Product hierarchy no. *				Part no.	SBU	Type / Description	Customer part no.
SBU PG	PGU	Type					
01	002	010	0000000525	0031.3981 0031.3991	Circuit protection	FBS2	n/a

2 Type of change

FBS2					0118.2292	
creation date	created by	release date	released by	notification no.	revision	page
2015-07-06	dislercy	2015-08-19	dislercy		-	1 of 1

Old marking	New marking

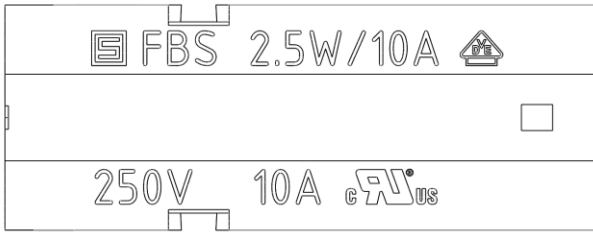
The marking on the socket of the fuseholder changes. The new marking includes VDE according IEC with rated voltage and cURus according UL/CSA with rated voltage and rated current.

Old marking	New marking
FBS VDE 2.5W/10A cURus 250V 10A	FBS2 VDE 250V cURus 250V 10A
